Interactive comment on “A novel explicit approach to model bromide and pesticide transport in soils containing macropores” by J. Klaus and E. Zehe

J. Klaus and E. Zehe

Received and published: 8 April 2011

Fig. 1. Retardation for $n > 1$

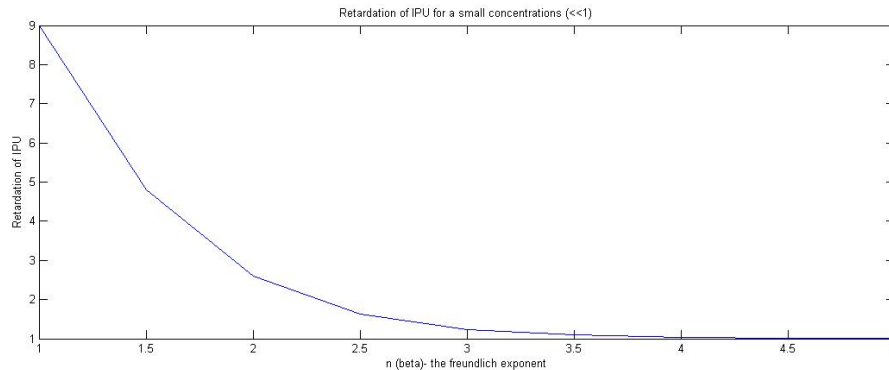
'Reviewer#3: The approach to IPU simulation probably contains (at least) one principal error! That is, the sorption isotherm is used for the 30-cm macropore domain without correction for the fact that reactions should occur only within the earthworm burrows. Of course the available surface area is much smaller in those burrows. A surface area weighted correction factor should yield much smaller effective KF-values for the macropore zones, as seems required here. Other issues are: I do not understand using $n=5$ in $C_a = k_f \cdot C^{\frac{1}{n}}$. $n=5$ gives an extreme increase in sorption for $C > 1$. So did you mean $n=1/5$? But I would rather reduce K_f instead of using an exponent > 1 .'

We will include useful runs with lower k_f values near zero, to support the IPU modelling with parameters of a better physical meaning and address the concerns of Mr.Köhne. Nevertheless, for $C < 1$ the approach of $n > 1$ is appropriate to reproduce retardation coefficients of 1 (see also comment to review#1). We attached a figure that shows the development of the retardation coefficient for $n > 1$ (and $C \ll 1$) to underpin this.
